May 6, 2020

RE: **Lot 5 Block 5 S.A.D. 227 Unit 5
6508 Onyx Ct. NW
Grading and Drainage Plan
Engineers Stamp Date 5/4/2020 (E10D069)**

DRAINAGE AND TRANSPORTATION INFORMATION SHEET (REV 6/2018)

ENGINEER'S SEAL	LOT 5 BLOCK 5 UNSER CLIFFS SUB 6508 ONYX COURT N.W. GRADING AND DRAINAGE PLAN	DRAWN BY DEM
		DATE 5-4-20
5/4/20		LOT 5 BLK 5 UNSER CLIFFS REVISED.DWG
DAVID SOULE P.E. #14522		SHEET # C1
	1606 CENTRAL AVENUE SE SUITE 201 ALBUQUERQUE, NM 87106 (505) 972-0899	JOB #

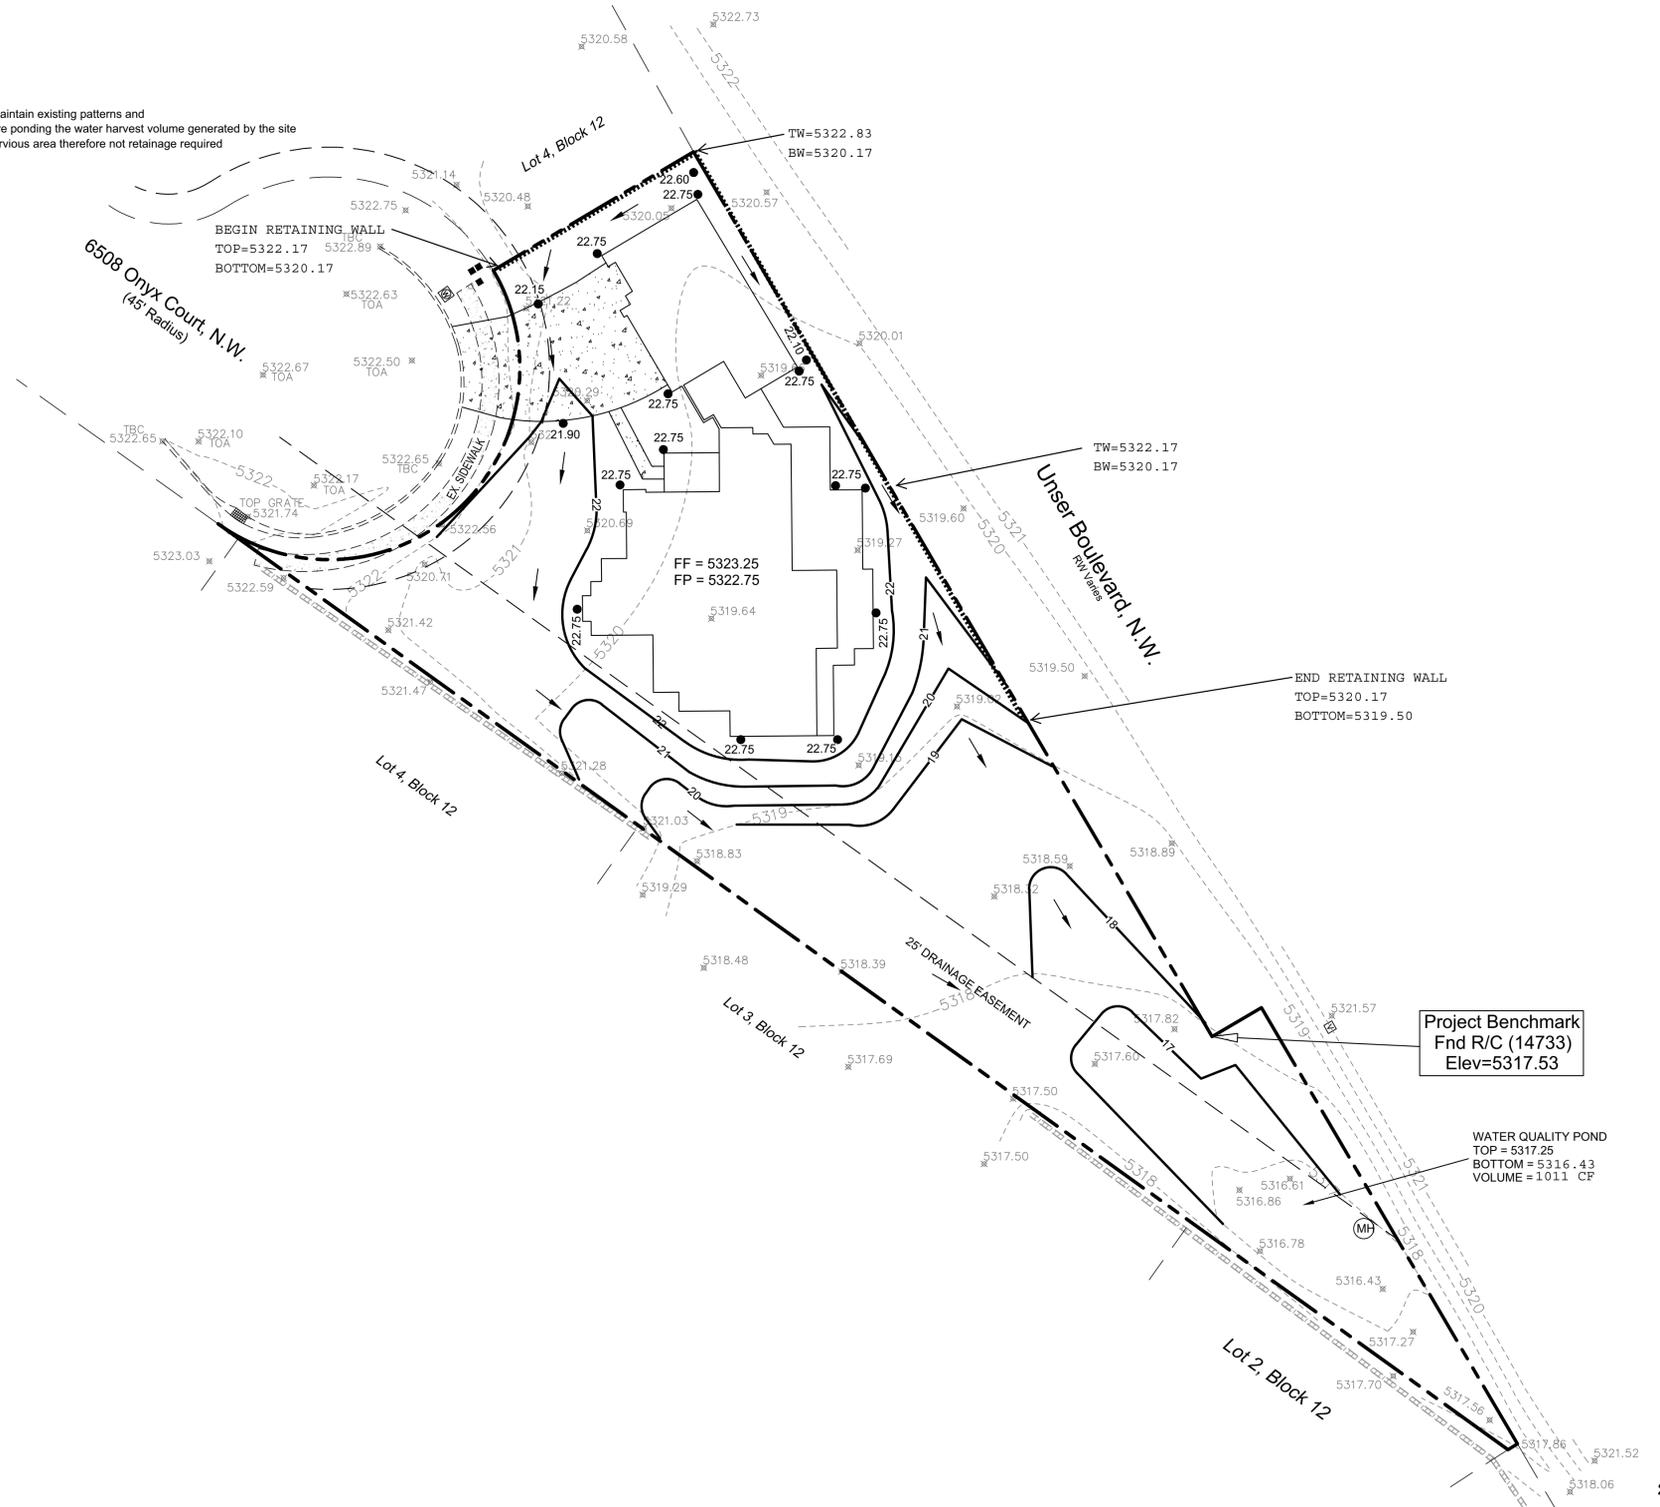
Based upon the information provided in your submittal received 5/4/2020, this plan is approved for Grading Permit. Please inform the builder/owner to attach a copy of this approved plan and letter into the construction sets in the permitting process prior to sign-off by Hydrology.

Reiterate to the Owner/Contractor that a separate permit for any garden/retaining wall must be obtained, with the approved G&D plan.

Prior to Building Permit approval, a **Pad Certification** will be required. Inform the contractor/owner not to pile dirt in the street as a ramp to climb the curb. If dirt is found in the street the pad cert. will be denied.

Prior to **Certificate of Occupancy release**, Engineer Certification per the DPM checklist of this plan will be required.
